November 7, 2007

RE: Esencia Subdivision L8/D016, Conceptual Grading Plan Approval

RE: ESENCIA SUBDIVISION CONCEPTUAL GRADING AND DRAINAGE PLAN,
TRACTS 21-25, ROW 3, UNIT B WEST OF WESTLAND (UNRECORDED
SUBDIVISION) AND UNPLATED TRACT OF THE ATRISCO GRANT , ZAP L-8

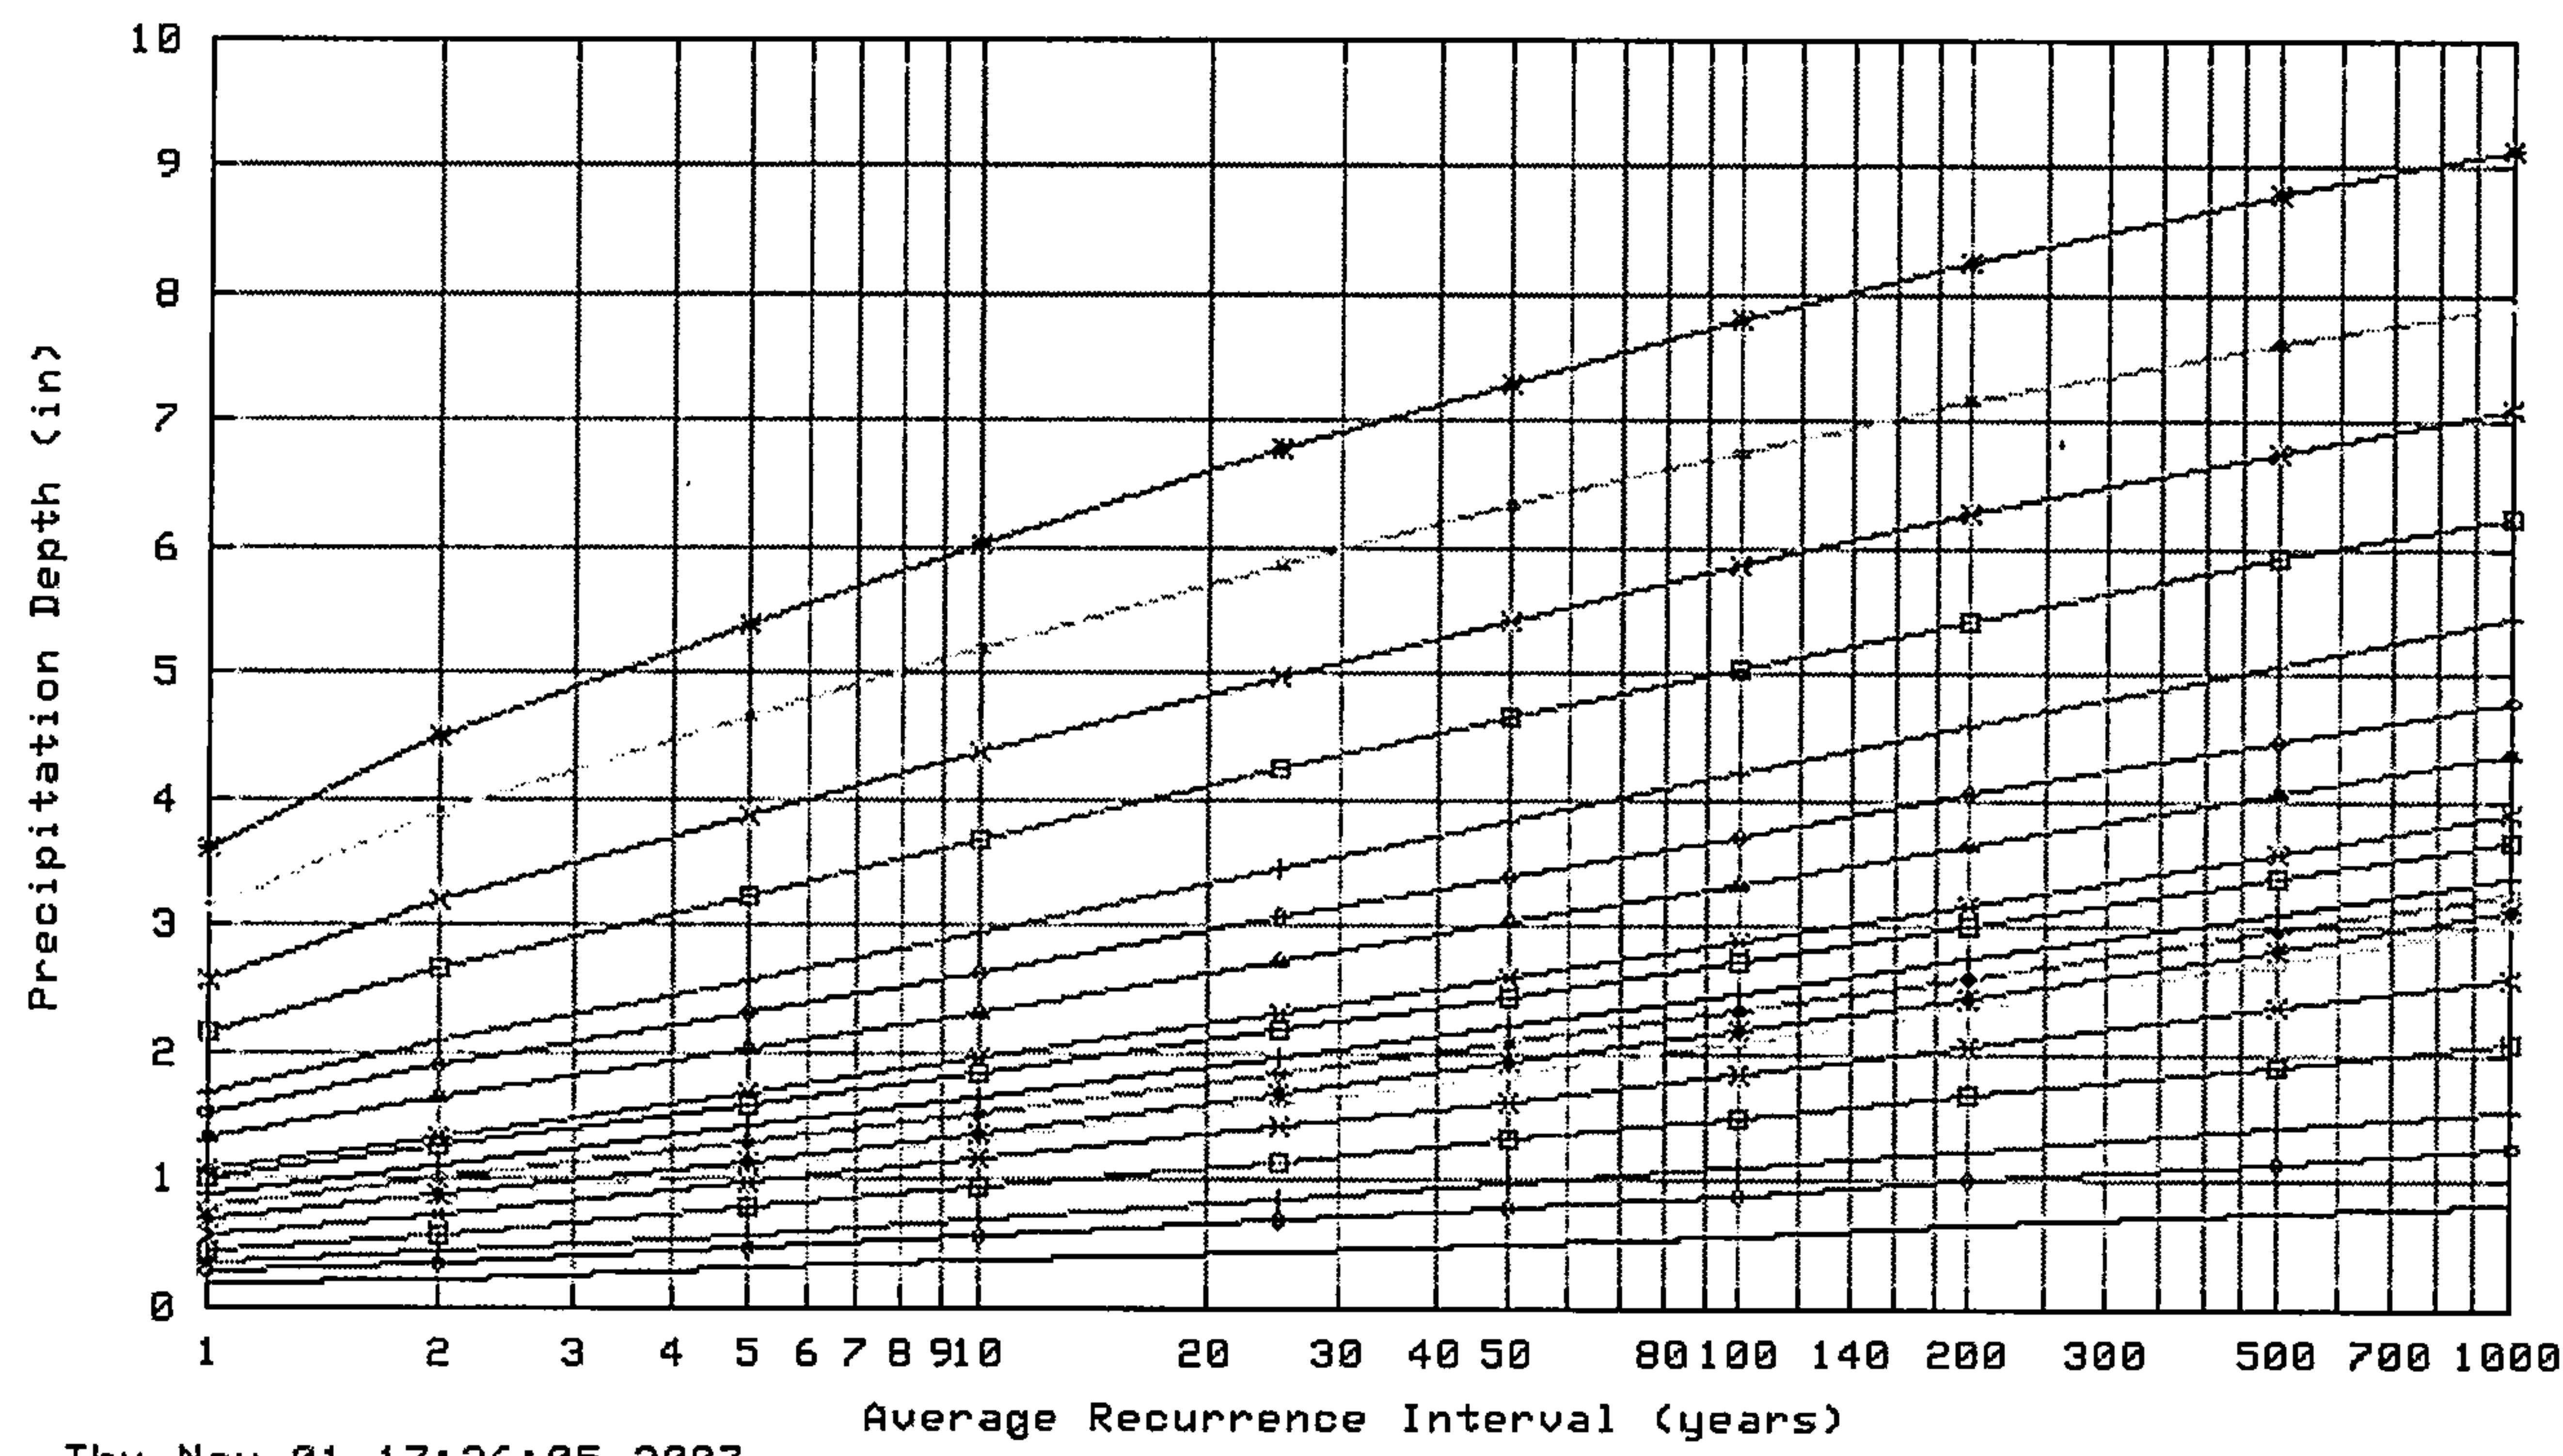
Maintenance Agreement in Place

Check downstream

AMAFCA approval

Show 32' wall

Recommend corner points for lots
